## DEVELOPMENT APPLICATION ASSESSMENT REPORT

<b>Application Number:</b>	DA2022/1425
----------------------------	-------------

<b>Responsible Officer:</b>	Jordan Davies
<b>Land to be developed (Address):</b>	Lot 1 DP 395093, 132 A Queens Parade East NEWPORT NSW 2106
<b>Proposed Development:</b>	Demolition works, construction of a dwelling house with partial retention of existing structure and new swimming pool
<b>Zoning:</b>	C4 Environmental Living
<b>Development Permissible:</b>	Yes
<b>Existing Use Rights:</b>	No
<b>Consent Authority:</b>	Northern Beaches Council
<b>Land and Environment Court Action:</b>	No
<b>Owner:</b>	Nigel Robert Love Judith Louise Love
<b>Applicant:</b>	BBF Town Planners

Figure 1 - Extract of plans showing setbacks to northern (rear) boundary.

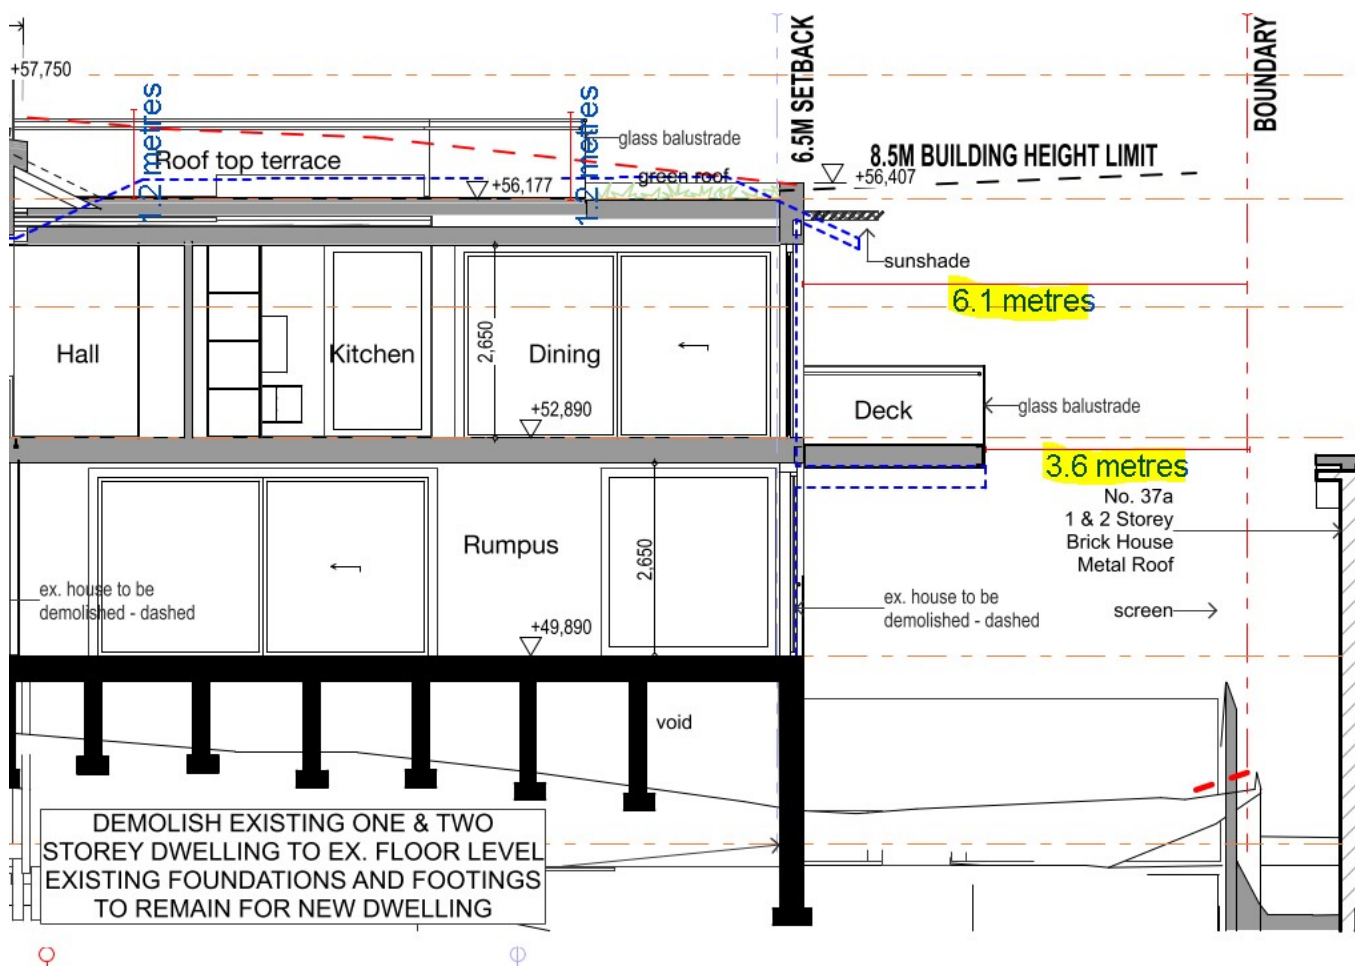
The DCP requires a rear setback of 6.5m. The proposal uses the existing footings of the building at the rear (north) of the site and reconstructs the two storey facade in same location, comprising of a 6.1m setback to the façade. The proposal also seeks to reconstruct the existing deck off the northern façade with the same setback of 3.6m. The below figure shows the proposed distance to the rear boundary, including the outline of the existing dwelling and deck indicated in blue.

Therefore, the rear setback is non-compliant and is considered against the outcomes of the control below.

**Figure 2 - West elevation encroachment, shown in red.**

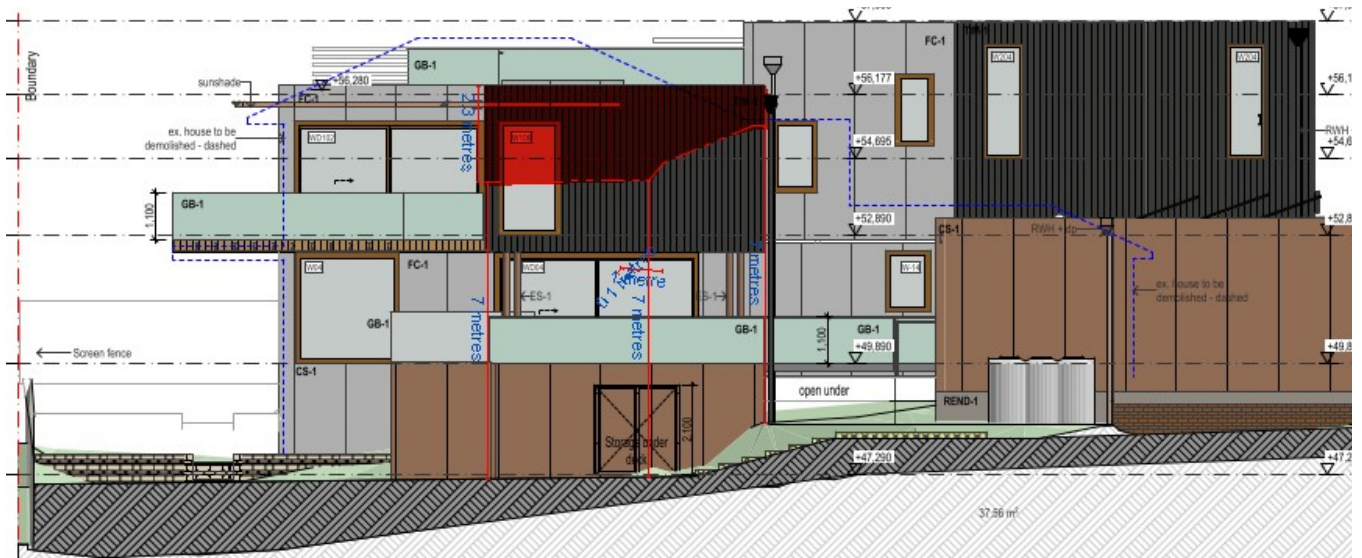
The extent of envelope breach is shown in the below figures for the western and eastern boundary. It is noted that the original plans submitted with the applicant had a larger breach of the building envelope for the master bedroom. Amended plans were received which reduced the height of the master bedroom to reduce the level of non-compliance.
